Planning Application
For Residential Development

Land at Crosshill
Codnor
Derbyshire

Technical Note 3
Response to DCC Highways Comments Dated 21/05/26

August 2026

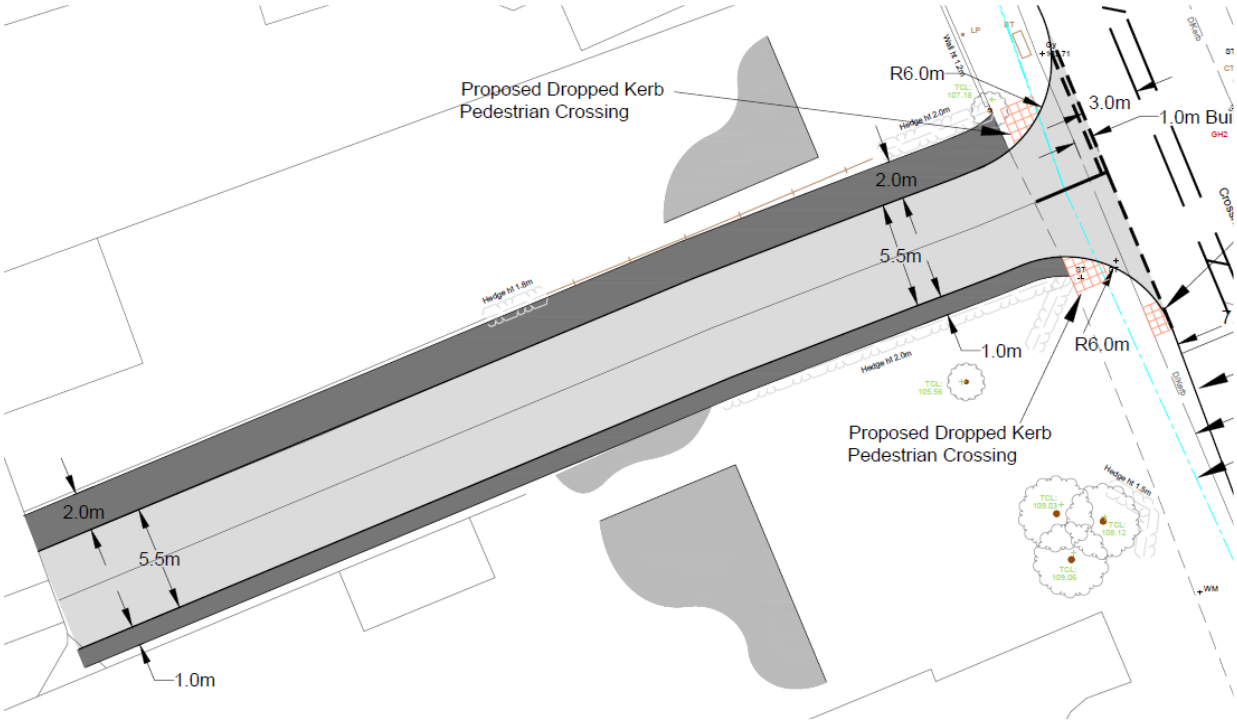
The following extract from drawing W153/100B/P shows part of the southern edge of the proposed 1m wide margin as being coincident with the centre line of the hedge which separates 17 Crosshill and the site access track. To the west of the hedge, the survey base mapping is lacking, and it is not clear where the southern edge of the 1m wide margin would be located relative to the adjacent boundary features.

It is not therefore clear, from a comparison of the above details, that there is sufficient width to accommodate the proposed site access road shown on drawing W153/100B/P, without affecting the extension to 17 Crosshill or without requiring removal of the hedgerow along the boundary between 17 Crosshill and the site access track.

The northern edge of the proposed footway along the northern side of the proposed site access road is close to the hedge which forms the boundary to 21 Crosshill. It is not therefore clear that the site access road shown on drawing W153/100B/P can be constructed without affecting the hedgerow along the boundary between 21 Crosshill and the site access track.

Further details are required to confirm the feasibility of implementing the proposed site access road without affecting third party interests.

The base survey mapping should be extended to include the whole of the site access track and its boundary features between Crosshill and the main body of the application site. Cross-sectional dimensions should be provided to confirm the available widths between the site access track boundaries. The applicant should confirm that the proposed site access road, with its 2m wide northern footway and 1m wide southern margin, can be constructed without adversely affecting adjacent third-party boundary features.

The applicant has obtained additional topographical survey information on the boundaries either side of the new access road. Having assessed the available land between adjacent property boundaries, two alternative access designs were submitted to DCC on the 17th July 26 for their comments. The first option illustrated on drawing W153/100C/P includes a 5.5m wide carriageway with a 2.0m footway to the north and a 0.75m margin to the south.

The second access option within drawing W153/100D/P, illustrates a carriageway junction width of 5.5m as required to accommodate satisfactory vehicle tracking, tapering to 5.0m as the access carriageway approaches the frontage of No. 17 Crosshill, circa 22.0m along the development highway. The 5.0m width is then maintained for the remaining length of the access. A 1.0m wide margin is included on the southern side of the carriageway with a 2.0m footway to the north. The 5.0m carriageway and footway / service margin provision accords with para. 5.7. – Pedestrian Prioritised Streets of PSP, and 5.7.1 with regards to the street's hierarchy for the number of plots proposed for this development. This street promotes carriageway varying widths of 4.1m - 6.2m.

DCC advised within their email correspondence of 29th July 2026 that they preferred a highway compliant with para. 5.7 - Pedestrian Prioritised Streets of PSP and thus access drawing W153/100D/P is to be promoted. A copy is appended to this TN.

Network Layout Diagram

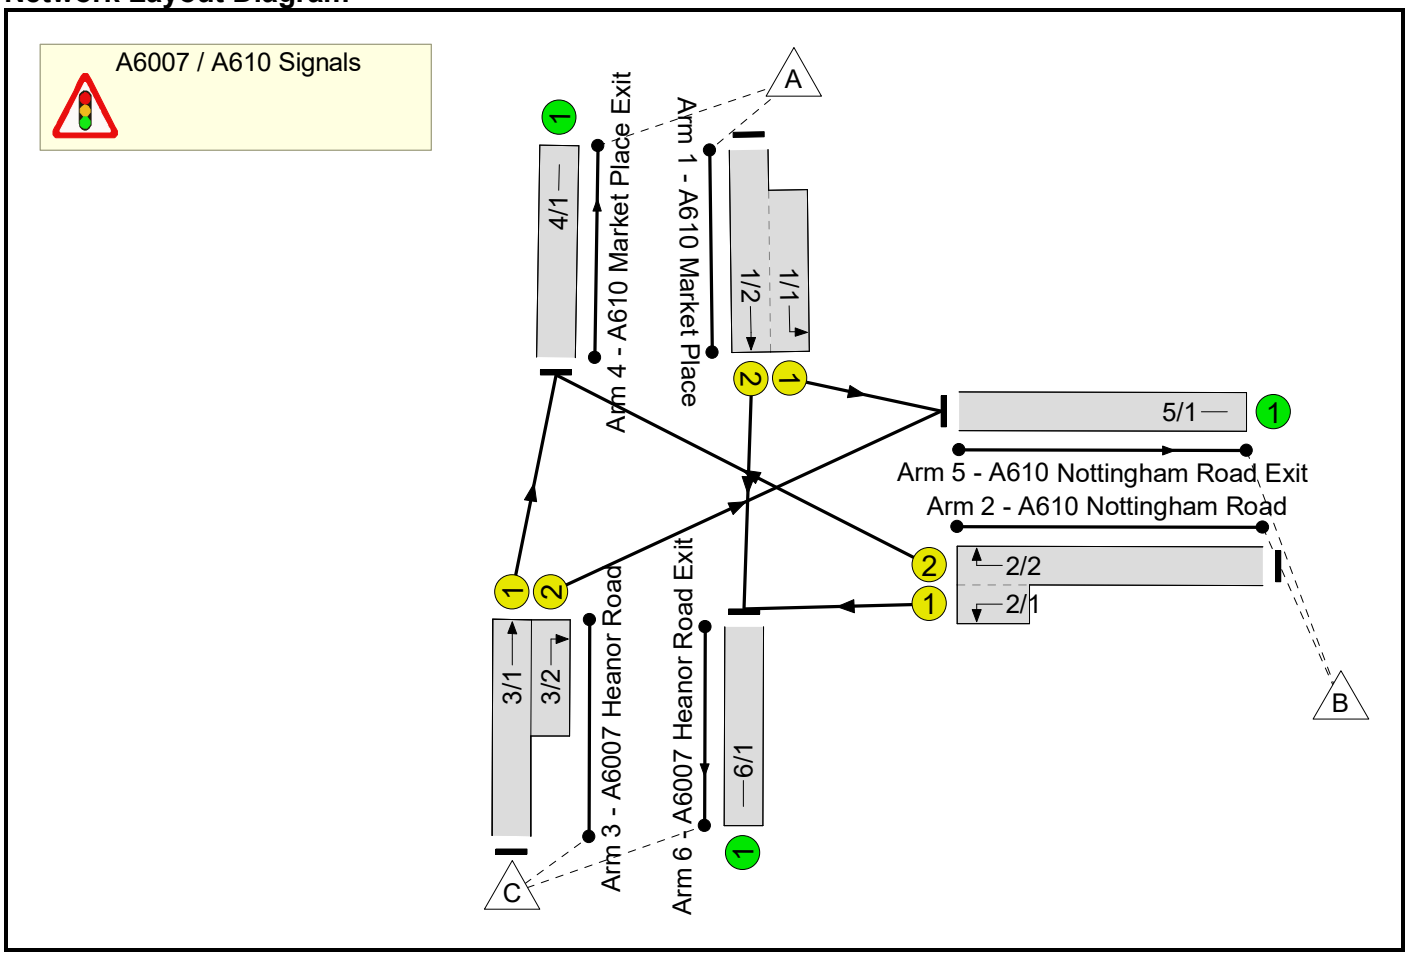
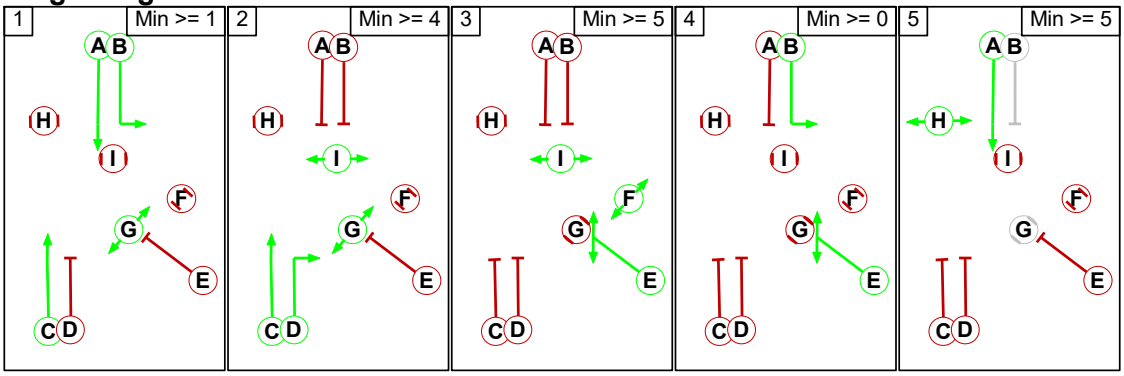
The following issues, some of which were referred to in the highway authority's 29/12/25 observations, must be addressed to ensure that the LINSIG modelling for the A610/A6007 junction is accurate:

1. Approach lanes should not all be coded as independent lanes as they do not act as such. Approaches should be set up with a main lane with a short lane of appropriate length attached.

2. The correct lane lengths should be used to represent the short lanes.
3. Right turn indicative arrow and left turn filter facilities should be coded correctly.

4. Prohibited stage moves should be coded correctly.
5. The stage order is primarily 1 – 2 – 4. Stages 3 and 4 are interchangeable but stage 4 will run during the peaks. Stage 2 is also demand dependent but is likely to run in all cycles during the peaks. Stage 5 is demand dependent and runs infrequently so can be omitted from the model.

6. The phase letters for each movement have changed and LINSIG should reflect those changes.
The A610/A6007 junction has recently been refurbished and the signal controller specification used in the applicant's junction modelling is now out of date. Updated details, together with a copy of the latest signal layout plan, to enable accurate measurements of lane lengths on the signal approaches to be determined, will be issued to the applicant's highway consultant under separate cover.

Revised traffic signal capacity assessments are required to allow the traffic impacts arising from the proposed development to be accurately determined. Such calculations should be provided in a technical note.

As requested, revised signal capacity (Linsig) assessments have been undertaken for the A610/A6007 junction using the signal timing, phasing, staging, intergreens and approach lane layout data supplied by DCC. As recommended by the 21/05/26 DCC comments the following has been incorporated within the modelling:

- **Each approach arm coded as single long lane with a short lane attached and revised lane lengths calculated.**
- **Right turn indicative arrow and left turn filter facilities coded correctly. Both have now been input as short lanes with their own separate phases as these are separately signalled on the Market Place and Heanor Road approach arms.**
- **Prohibited stage moves coded as per the latest signal timings data supplied by DCC.**
- **A 1 – 2 – 4 stage order adopted.**
- **Phase lettering reflecting the latest phasing data supplied by DCC.**
